## Appraisal Framework Module 14. Operational Efficiency: Ground Infrastructure Gatwick Airport Second Runway

**Project:** Airport Operations, Logistics and Engineering Support  
**Client:** Airports Commission Project No: B1988000  
**Document title:** Appraisal Framework Module 14. Operational Efficiency: Ground Infrastructure Gatwick Airport Second Runway  
**Ref. No:** GAL01

**Figure 3-1 Gatwick Airport Second Runway Master Plan (base plan for midfield apron)**

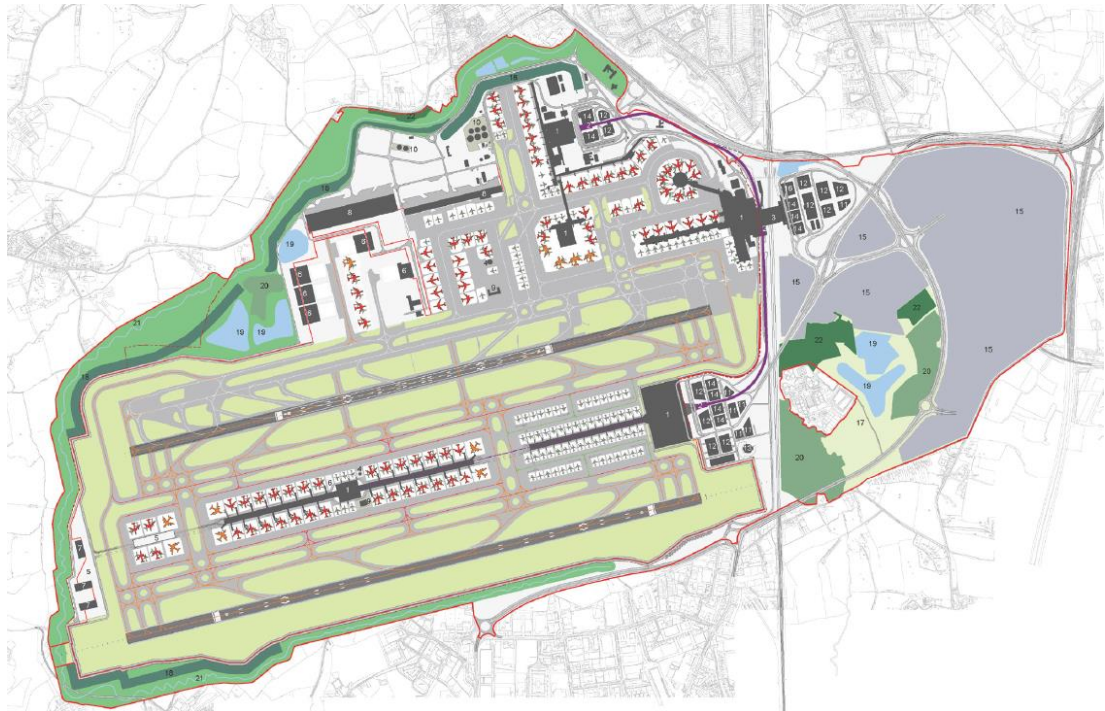
The master plan appears to have been laid out in accordance with CAP168.<sup>3</sup> It is anticipated that it will be also be necessary to be compliant with EASA regulations, which differ from CAP168.<sup>4</sup> The airfield proposal does not appear to comply with current EASA requirements in a few instances as discussed in the followings sections. It is possible the UK CAA could seek a permanent variation from EASA regulations for this scheme (based upon GAL demonstrating that the airport could operate safely with appropriate operating procedures in place). In addition, EASA has issued a consultation paper that proposes to reduce taxiway clearances, in line with ICAO proposals to do so from 2016.<sup>5</sup> If the EASA proposals were adopted, then the taxiway clearances requirements would be less onerous than at present.

However, if existing EASA regulations are confirmed to be mandatory, there nonetheless appears to be sufficient space to accommodate the additional clearances necessary to meet EASA regulations, although this would reduce the space currently allocated to stand depth, airside roads and terminal structure

**Figure 4-1 Gatwick Airport Second Runway Proposed PSZs (Source: Gatwick Airport Ltd submission to the Airports Commission)**

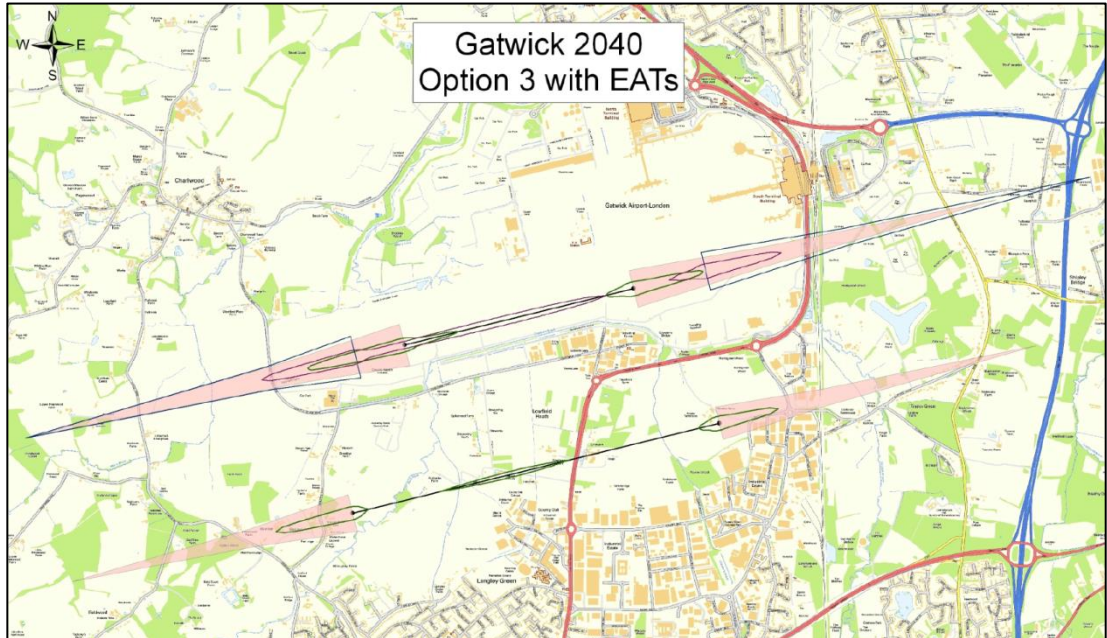
Figure 4-1, on the next page, illustrates the proposed PSZ contours. At this stage of planning, the contours should be considered to be indicative only and subject to change dependent on future operating parameters and aircraft mix.

Figure 5-1 Taxiway Operational Pinch Points

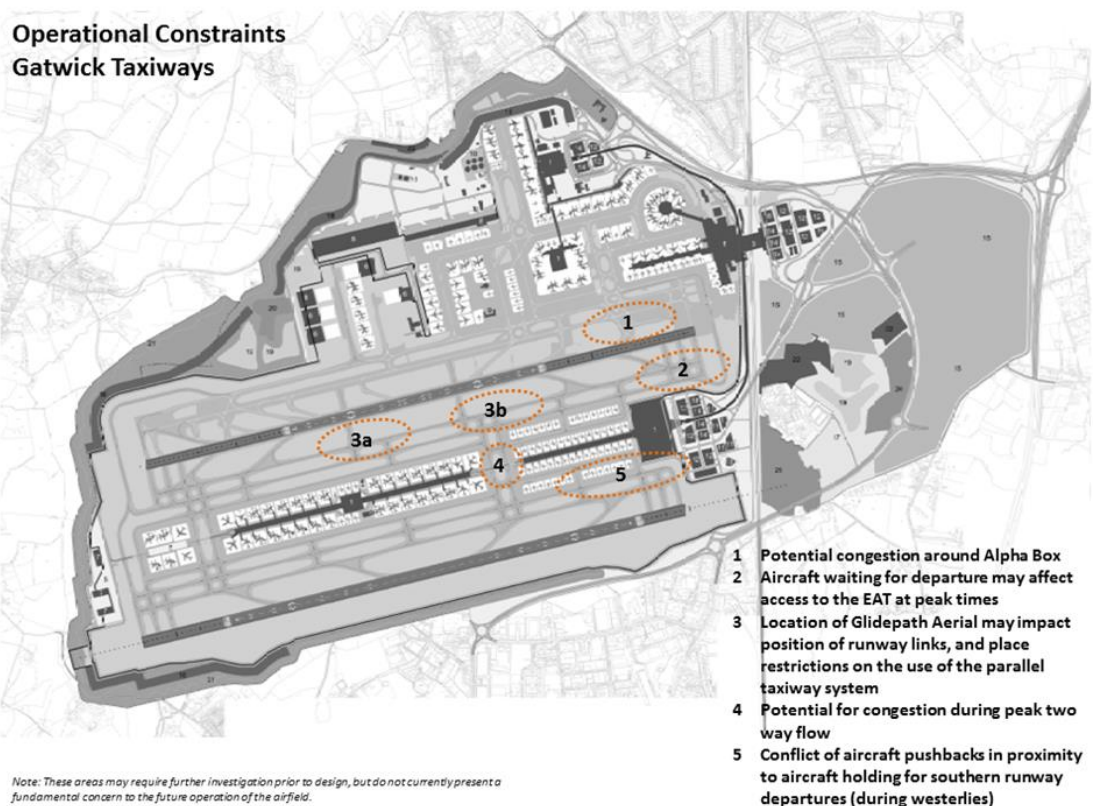
The proposed network would appear to be adequate to manage aircraft efficiently on the airfield. However, some bottlenecks have been identified in the network that could cause congestion during peak periods. These are highlighted in Figure 5-1 below.

The existing runway is served by an area of pavement known as the ‘Alpha-Box’ which is to the northeast of the existing runway 26L threshold (see area marked “1” in Figure 5-1 above). This area is used for sequencing of departing aircraft on westerly operations. The Alpha Box protects the runway under CAT II<sup>14</sup> and CAT III<sup>15</sup> conditions by positioning stop-bars so that holding aircraft are located outside the approach surface when landing operations are on runway 26L. Due to this constraint the ‘Alpha Box’ is currently a bottleneck at peak times, particularly under conditions of CAT II and III landings when departing aircraft are held outside the box whilst an aircraft approaches and lands.

The dual taxiway network includes a pinch point between the Midfield Terminal and satellite (see area marked "4" in Figure 5-1 above). This is likely to be a critical area during times of peak operations during westerlies.

Overall, taxiway circulation appears to be acceptable. However, the areas depicted in Figure 5-1 above are potential bottlenecks that are likely to present some delays at times of peak operation, although these should be able to be mitigated by appropriate operational procedures.

The congestion “pinch points” under peak operating conditions that could create delays and affect the reliability of airport operations are as follows (and as shown on Figure 5-1 above):

At peak times, it is likely that the capacity bottlenecks shown on Figure 5-1 above will affect the efficiency of the airfield. However, careful design of operational procedures to dynamically respond to congestion, by managing departures and runway and taxiway utilisation may mitigate potential delays.

It should be noted that a series of remote stands are located to the south of the Midfield Terminal pier (at the eastern end of the airfield). Access to these stands could impact operation of pier served stands along the terminal at peak times and that pushback onto the parallel taxiway system could compromise efficient flow of aircraft during busy periods (see area marked “5” in Figure 5-1 above).

**Figure 8-1: New Midfield Terminal and Satellite Building**

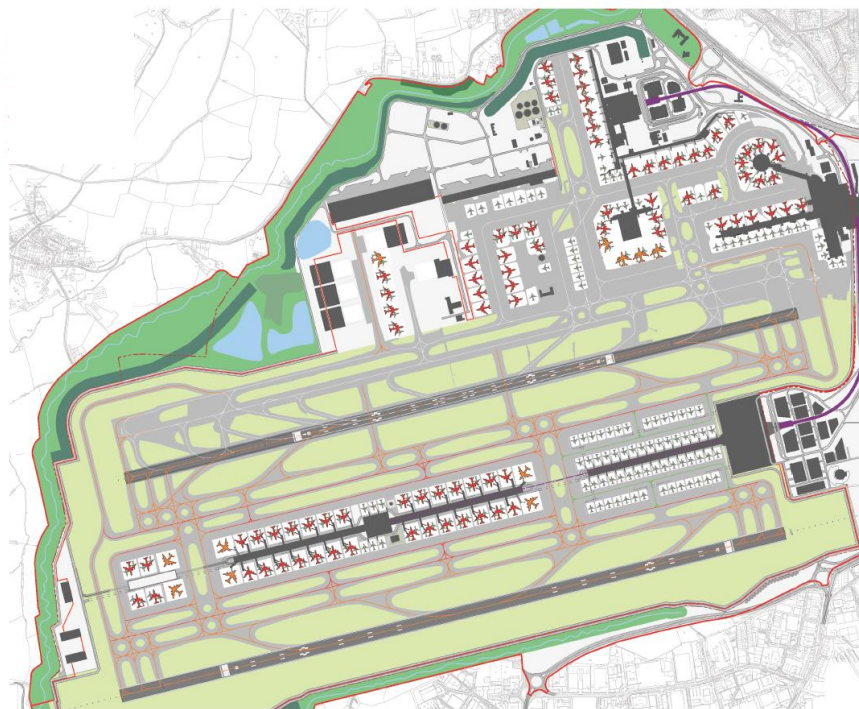
The proposed Midfield Terminal, as shown in Figure 8-1, centralises most departure and arrival passenger processes under one roof and serves as a single landside connection point. This centralisation would appear able to permit an efficient operation.

**Figure 8-3** Space Planning Factor for Airports with more than 20 mppa, Showing All Phases of the Proposed Scheme

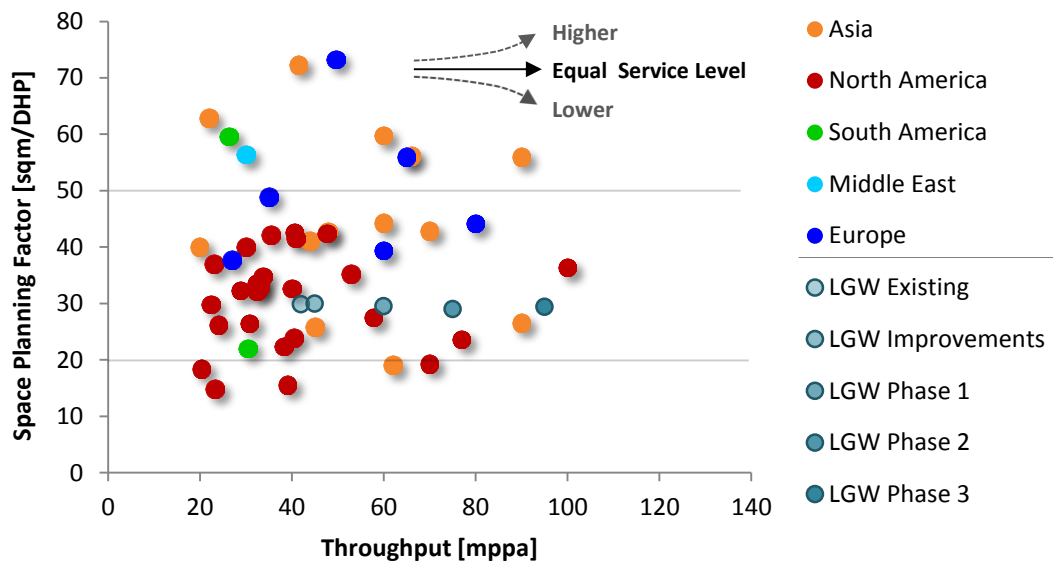
With reference to Section 2.7, Table 8-1 and Figure 8-3 demonstrate that the airport, at its current capacity, can operate at a reasonable level of space allocation given the nature of its operation and predominant types of airlines. During the full build-out of the Midfield Terminal the space allocation per passenger would be similar to the existing terminals today. However, as the airport grows and expands, the space allocation per passenger remains at the average, but towards the low end provision in the context of international “gateway airports” of comparable size. The scheme could, therefore, be seen as optimised to accommodate primarily short-haul, point-to-point passengers, who might be likely to spend less time in terminals, and fewer transfer passengers.

It should be noted that this benchmark serves as an indication of space provision. Two factors can have an impact on the level of space provision and level of service experienced in two airports close to each other in the benchmark: the number of international and, to a lesser extent, transfer passengers. As the former require separate facilities as opposed to domestic passengers (immigration for example) and their dwell times are often longer, more space ought to be provided within the terminal building. Similarly transfer passengers require separate facilities and longer dwell times can be observed to increase the space requirement of the terminal. The scheme is, therefore, seen as providing a reasonable space allocation within the wider industry benchmark, but towards the lower end for international “gateways”.

Figure B-1 Space Planning Factor for Airports with more than 20 mppa, Showing Three Phases of the Proposed Scheme and the Intermediate Phase

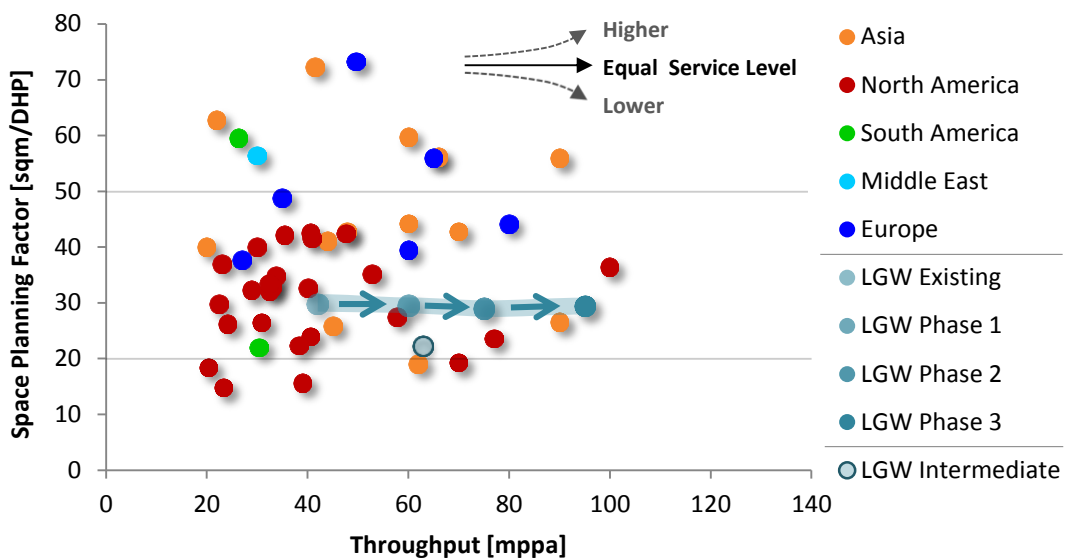
As only 15,000 m<sup>2</sup> additional floor area is provided during the Intermediate Phase<sup>20</sup>, the space planning factor would reduce from today’s circa 30 to around 22 m<sup>2</sup>/DHP, or a decrease of a quarter, as shown by the “LGW Intermediate” data point in Figure B-1 below.

Note that, regardless of the absolute value of the gross floor area or the passenger design hour factor being applied the space planning factor reduces by around a quarter between today’s standard and that which would be achieved at the end of the Intermediate Phase.

Whilst recognising the limitations of the space planning factor, it is also reasonable to observe that there is an established relationship between space provision and passenger experience. The analysis suggests that GAL's proposed phasing may reduce the space available per design hour passenger, at its lowest point, by around a quarter of what it is today. GAL proposes to mitigate this through suggested process improvements and changes in customer behaviour, which compensate for this loss of space to enable continuing performance against the Airports Commission's objective of improving the passenger experience. Adopting a risk based approach, the Airports Commission has assessed a phasing which broadly maintains the same space available per passenger throughout the lifetime of the scheme, ensuring that the passenger experience is less reliant on the realisation of these proposed improvements and would enhance the passenger experience, relative to today, should these benefits come to pass in future years. Furthermore, certain factors are not in the hands of the airport operator and the opening of a 2<sup>nd</sup> runway is likely to disproportionately increase the peak hours rather than off-peak hours, as this would be determined by the airlines, further increasing passenger demand at peak times, which may reduce service standards to a level that may not be acceptable to the airlines or the CAA. We note, however, that the construction and phasing of terminal and passenger processing infrastructure would ultimately be a commercial decision for the airport operator.

**Figure B-2** Space Planning Factor for Airports with more than 20 mppa, Showing Two Proposed Phases, with the Size of the Marker Indicating the Percentage of International Seats<sup>22</sup>

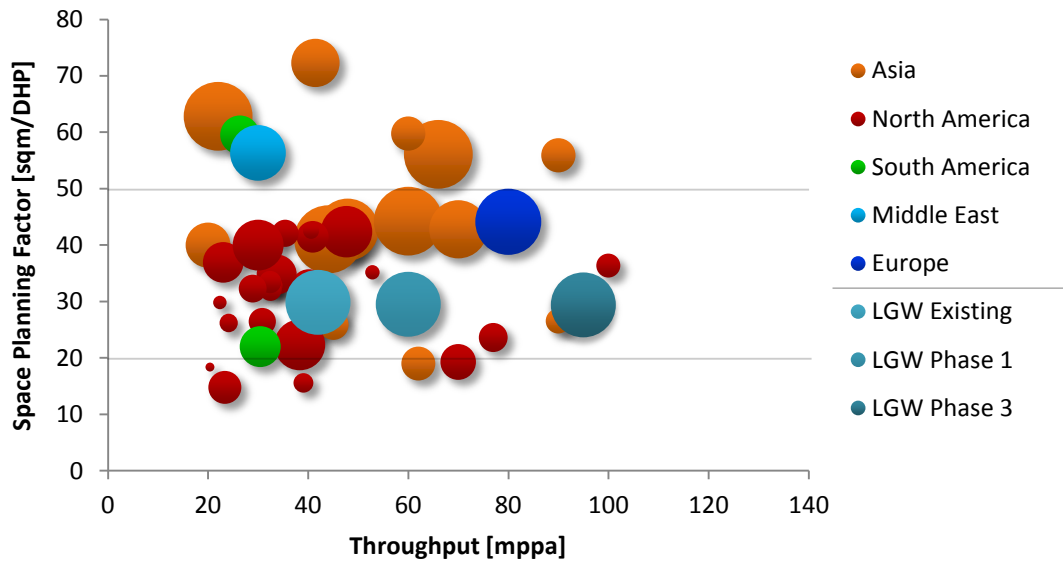
It is noted that the number of international passengers has an impact on the space and facilities required at an airport or terminal as discussed in Section 8.3. Figure B-2, shows that airports that tend to treat fewer international passengers can be found at the lower end of the space provision benchmark (below circa 35 m<sup>2</sup> per DHP). It is noted that GAL’s proposed scheme could be regarded as towards the lower end of provision for an airport serving a large proportion of international passengers.

We note GAL’s view, as set out in Table B-1, is of a larger GFA than has been assessed, but this fits within the range of uncertainty accounted for by the 5% upper and lower bandwidth as detailed in Section 8.3.
